UNITED STATES PATENT AND TRADEMARK OFFICE

APPLICATION NO.	FILING DATE	FIRST NAMED INVENTOR	ATTORNEY DOCKET NO.	CONFIRMATION NO.
10/553,048	10/12/2005	Kazuharu Mishimagi	JG-SU-5218/500577320068	2476

Office Action Summary	Application No. 10/553,048	Applicant(s) MISHIMAGI, KAZUHARU	
	Examiner Paul A. Chenevert	Art Unit 3612

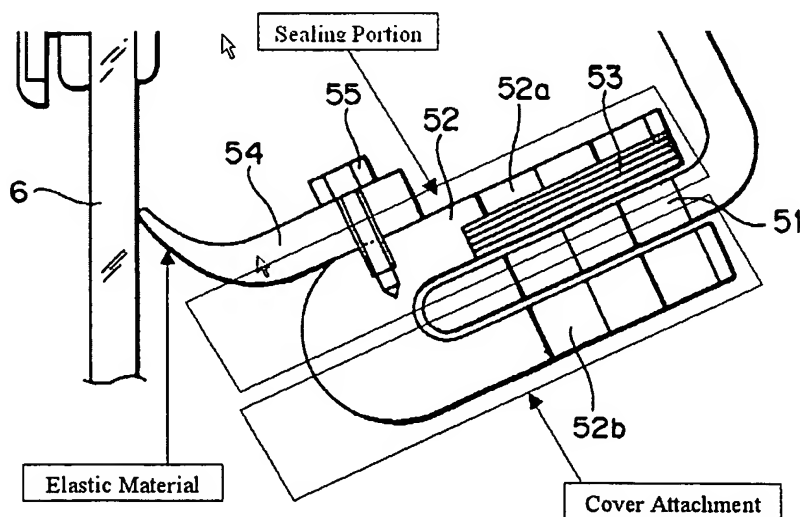
8. Claims 1 & 4 are rejected under 35 U.S.C. 102(b) as being anticipated by Iino.

Iino discloses a vehicle side visor cover, which is attached on a side visor (10), the side visor cover comprising: a cover attachment portion attached on an outer surface of the side visor; a sealing portion whose outer rim is integrally connected with the lower edge of the cover attachment portion; and an elastic material as shown in the detailed Figure 11 below.

In regards to claim 4, the side visor cover is attached to lower outer surface of a horizontal portion of the side visor.
